McIntosh

MX 112

SERVICE INFORMATION

SERVICE BULLETIN

MX 112
S.B. No. 2

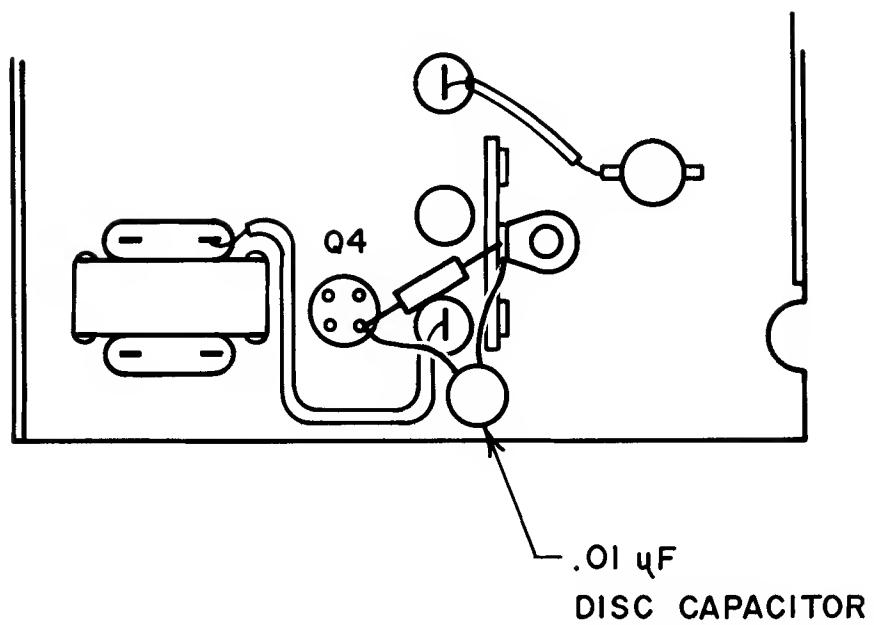
AM NOISE REDUCTION MODIFICATION

PURPOSE OF MODIFICATION: To improve AM signal to noise ratio.

WHEN MODIFICATION SHOULD BE MADE: When customer complains that AM is noisy on local stations or that sensitivity is poor.

- Step 1 Remove bottom cover, Multiplex-AM top cover, and RF front end bottom cover. Remove capacitors C204 and C208 on AM PC board. See service manual for exact location. Replace top cover.
- Step 2 Locate Q4, AM RF amplifier in RF front end chassis. Connect the .01 μ F disc capacitor between the source terminal of Q4 and the ground lug of the terminal strip as shown in the accompanying sketch. Replace bottom covers.
- Step 3 Check performance. If dial calibration is off at high end of the band, perform AM alignment steps 3 and 5 in service manual. The top cover of the RF front end is removed for access to the alignment trimmers.
